CONTINUATION SHEET

Sketches SKA-002, SKE-3, SKE-4, SKE-5, SKE-6, SKE-7 and SKE-8 are added to the list of drawings. These sketches accompany this amendment.

NAVSUPPORT NORTHWEST ANNEX CHESAPEAKE, VA REPAIR AND RENOVATE BARRACKS 351

ENLARGED TYPICAL SLEEPING ROOMS WINDOW TYPES

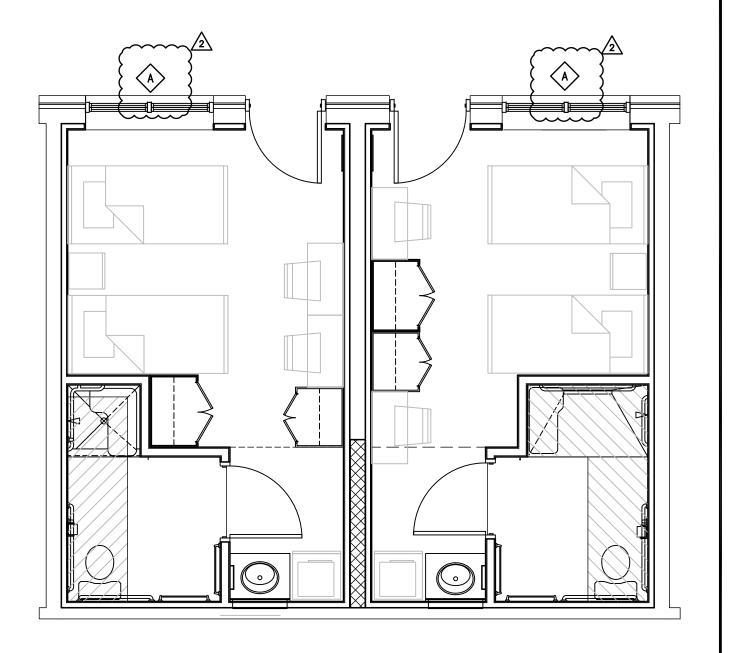
THIS DRAWING REVISES IN PART DRAWING NO. SUPPLEMENTAL DRAWING NO. SKA-002

E-104

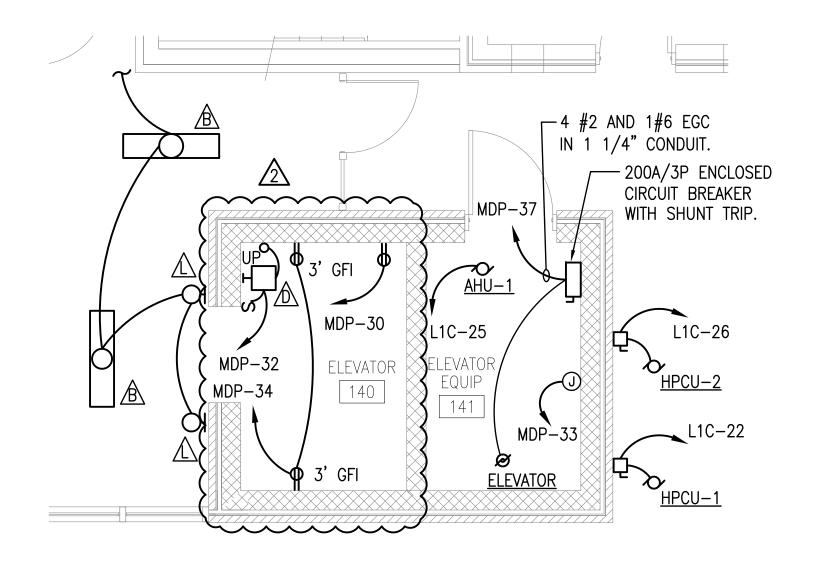
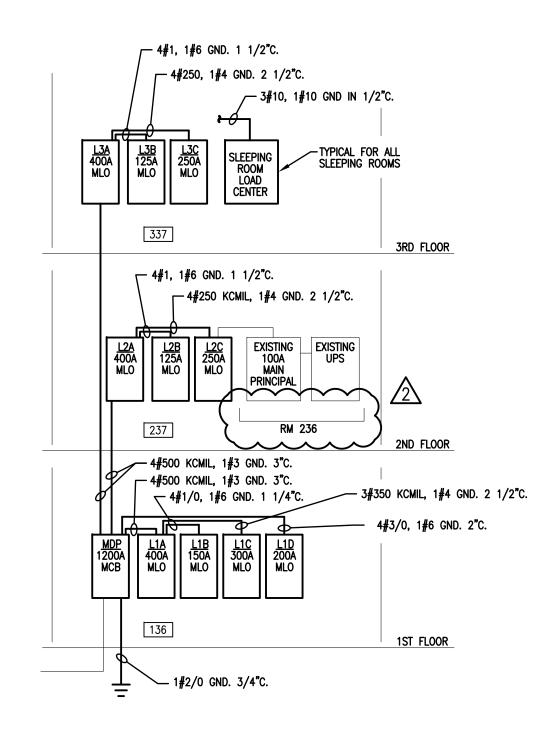
PROVIDE VISIBLE NOTIFICATION DEVICE TO ALERT ROOM OCCUPANTS OF INCOMING TELEPHONE CALLS AND A DOOR KNOCK OR BELL

CHANGE VANITY LIGHT SWITCH TO A DIMMER SWITCH

PARTIAL THIRD FLOOR PLAN - AREA B - LIGHTING

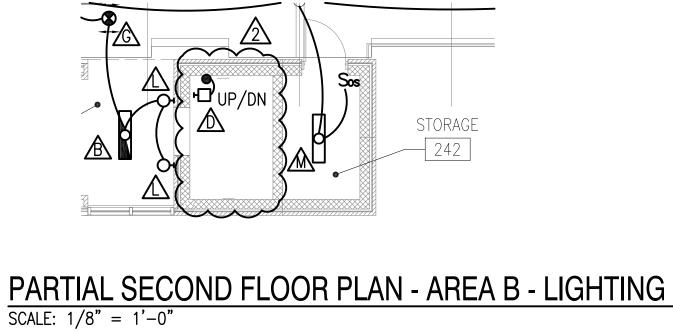
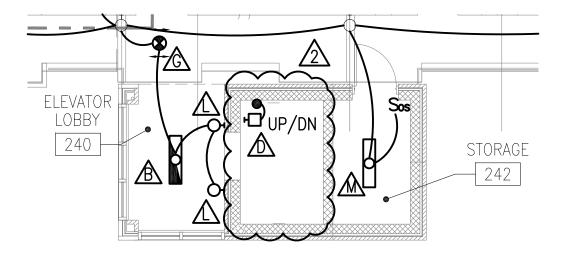
REVISED LIGHTING IN ELEVATOR SHAFT

REVISED LUMINAIRE DETAIL

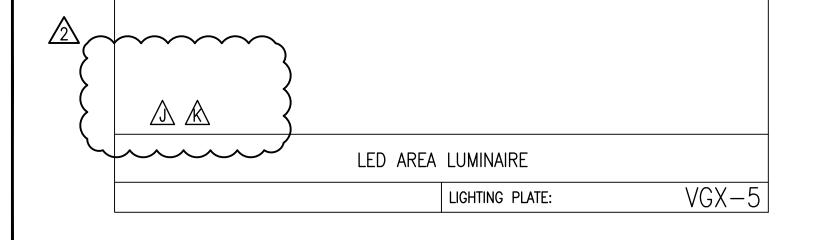
- 1. HOUSING EXTRUDED ALUMINUM OR FABRICATED DIE-FORMED ALUMINUM WITH SEALED AND WELDED SEAMS.
- 2. FINISH MULTI-STAGE PRE-TREATMENT, FINISHED WITH BAKED-ON POLYESTER POWDER COAT. OPTIONAL ARCHITECTURAL CLASS 1 ANODIZE FINISH AVAILABLE AS INDICATED. FIXTURE SHALL PASS 2500 HOUR SALT SPRAY TEST FOR CORROSION RESISTANCE. DARK BRONZE OR BLACK STANDARD FINISH. OTHER FINISHES AVAILABLE AS INDICATED.
- 3. LIGHT ENGINE LED BOARD(S) WITH INDIVIDUAL OPTICS MODULES TO ACHIEVE DESIRED OUTPUT & DISTRIBUTION. DISTRIBUTION & MINIMUM LUMEN OUTPUT AS NOTED ON SCHEDULE.
- 4. DRIVER 0-10V DIMMING OR STEP DIMMING. >0.9 POWER FACTOR, <20% THD 120-277 V
- 5. CERTIFICATION UL LISTED AND CERTIFIED FOR WET LOCATIONS. LM79/LM80 COMPLIANT.
- 6. OPTIONS PHOTOCELL AND RECEPTACLE, CUSTOM COLOR AS INDICATED, FUSING & HOUSE-SIDE SHIELD.
